Access Compliance Report

Public Rights-of-Way

(Curb Ramps)

Intersection ID: 48600	Main Street: LITTLE_GEM_LN	Cross Street: GRANDIFLORA_DR	Location: W
ADA ID: AC502E8CFDBD	Ramp Type: Perp	Initial Pass/Fail: Fail	Overall Compliance: No
Severity Score: 13.75			
Codes/Mitigation Info/Possible Solution		Field Measurements/Component Compliance

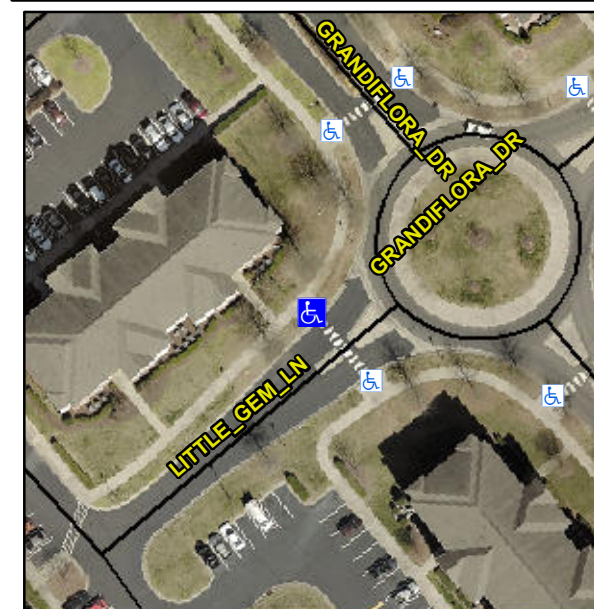
Not Found, R304.2.2, R304.5.3

Compliance	Description	Data	Compliance	Description	Data
N/A	Ramp Length (in)	94.0	No	Ramp Slope (%)	9.6
Yes	Ramp Width (in)	50.0	No	Ramp XSlope (%)	2.3
N/A	Flare Type LT	N/A	N/A	Flare Type RT	N/A
N/A	Flare Slope LT (%)	N/A	N/A	Flare Slope RT (%)	N/A
N/A	Flare Traversable LT?	N/A	N/A	Flare Traversable RT?	N/A
N/A	Landing Length (in)	N/A	N/A	DWS Provided?	N/A
N/A	Landing Width (in)	N/A	N/A	DWS Contrast?	N/A
N/A	Landing Slope (%)	N/A	N/A	DWS Length (in)	N/A
N/A	Landing X Slope (%)	N/A	N/A	DWS Full Width?	N/A
N/A	Landing Curb? (Y/N)	N/A	N/A	DWS Offset (in)	N/A
N/A	Shared Landing?	N/A			
N/A	Gutter Ponding?	N/A	N/A	Gutter Slope (%)	N/A
N/A	Gutter Lip Ht (in)	N/A	N/A	Gutter X Slope (%)	N/A
N/A	Painted X Walk1?	Yes	N/A	Painted X Walk2?	N/A
	X Walk 1 Direction	To SW		X Walk 2 Direction	N/A
N/A	X Walk 1 Width (in)	57.0	N/A	X Walk 2 Width (in)	N/A
	X Walk 1 Slope (%)	1.8		X Walk 2 Slope (%)	N/A
	X Walk 1 X Slope (%)	1.3		X Walk 2 X Slope (%)	N/A

Remove & Replace Entire Ramp.
